Accessibility Site Visit Report - HC - ANSI

Project Name	Sample Property
Visit Type	3rd
Date of Inspection	02-12-2020
Inspector	Brian White
Site Visit Accompaniment	Jason Pendly
Street Address	123 Main St
City	Greenville
State	South Carolina
Zip Code	29605
Accessibility Codes for this project (Check if used)	2010 ADA, ANSI A117.1, UFAS
Number of Buildings	1
Total Number of Units	80
Number of HC Accessible Units	5
Number of A/V Units	0
Number 1 Bedroom Units (Std/HC)	80/5
General Project Notes:	NOTE – Element Findings at Time of Inspection: This inspection report indicates individual elements as Yes, No, or N/A. Each

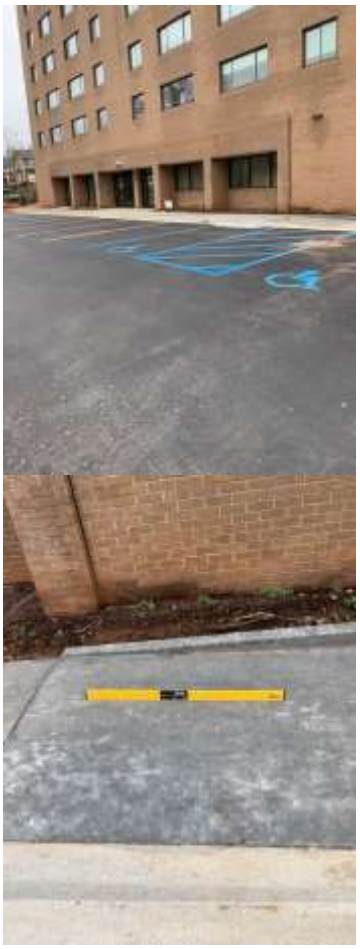
Location of Parking	Basement Entrance
HC Parking Status	Finished
Surface type	Asphalt
HC parking spaces the closest parking to the nearest location: (2010 ADA 208.3.1 UFAS: 4.6.2 FHA 2.20)	Yes
Parking space at least 96" wide (ADA 502.2 UFAS 4.6.3 FHA 2.21)	Yes
Is access aisle the full length of the parking space (ADA 502.3.2 UFAS 4.6.3 FHA 2.21)	Yes
Is access aisle proper width 5' (ADA 502.3.1 UFAS 4.6.3 FHA 2.21)	Yes
Is the slope and cross-slope of parking space no more than 2% in all directions (ADA 502.4 UFAS 4.6.3)	Yes
Is the slope and cross-slope of access aisle no more than 2% in all directions (ADA 502.4 UFAS 4.6.3)	Yes
Does each HC parking space have a sign with ISA mounted at least 60" above the	No

space to the bottom of the signage (ADA 502.6 UFAS 4.6.4 FHA 2.21)	
Curb ramp slope does not exceed 8.33% (ADA 405.2 UFAS 4.8.2)	Yes
Curb ramp cross-slope no more than 2% (ADA 405.3 UFAS 4.8.6)	Yes
Curb ramp at least 36" wide (Flared sides) 48" min. C/I ramp (ADA 405.5 UFAS 4.8.3)	Yes
Cut-In curb ramp landing at least as wide as curb ramp and adjoining accessible route (UFAS 4.8.4)	Yes
Accessible Parking Photos

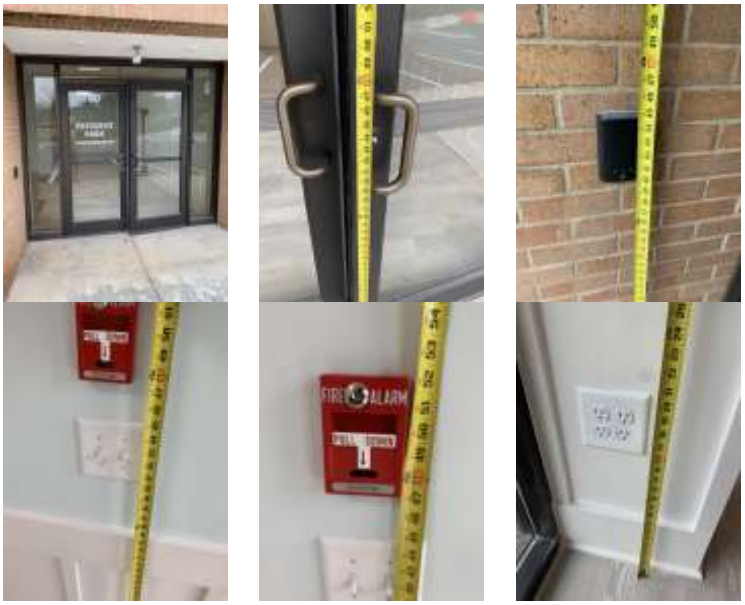
12" min. clearance on the push side of the door (with door closure) (ADA 404.2.1)	Yes
Does the door take at least 5 seconds to close (2010 ADA 404.2.8.1)	Yes
Electric switches 48" max. AFF and outlets 15" min. (unobstructed) (ADA 308.2.1)	Yes
Interior signs mounted (latch side) have tactile characters (measured from the baseline) between 48" min. - 60" max. (ADA 703.4.1)	Yes
Interior sign characters at least 5/8" but no more than 2" tall (ADA 703.5.5)	Yes
If required per NFPA fire alarm pull station permanently installed 48" max. AFF	No
Community Room Photos
